Work Order ID 123683

Item Name: Bracket

APICAL INDUSTRIES, INC.	ENGINEERING CHANGE NOTICE NO. 03697				SHEET 1 OF 1	
	DWG NO. 646.3800	REV: N/C	PREPARED BY B. PETERS	DATE: 11/14/12	EFFECT ON DWG <input type="checkbox"/> INC. <input checked="" type="checkbox"/> UNINC.	
	DWG TITLE: BRACKETS					
	APPROVED BY: ENGR <i>[Signature]</i>	MFG <i>[Signature]</i>	QC <i>[Signature]</i>	EFF: NEXT ORDER		
TRANSACTION CODES (TC): A-ADD C-CREATE R-REVISE D-DELETE	REASON: ADDED ALTERNATE MATERIAL.				ECR: D-12-006

646.3810

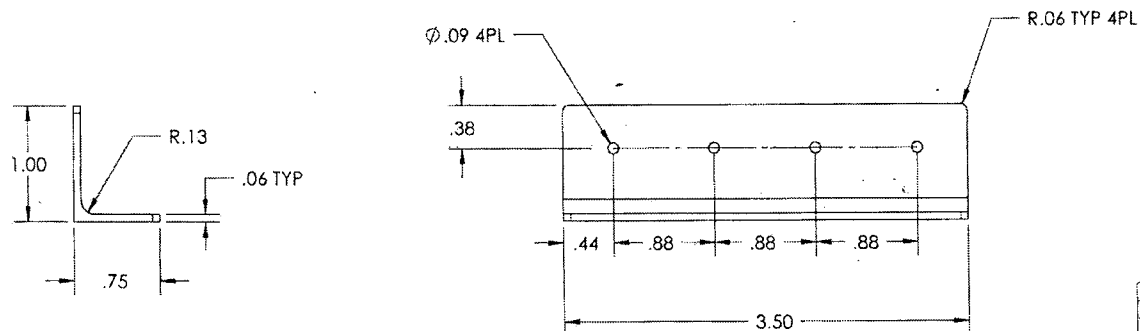
1 PRIMARY MATERIAL: 7075-T651 ALUMINUM PER AMS-QQ-A-250/12.
ALTERNATE MATERIAL: 7075-T6511 ALUMINUM PER AMS-QQ-A-200/11.
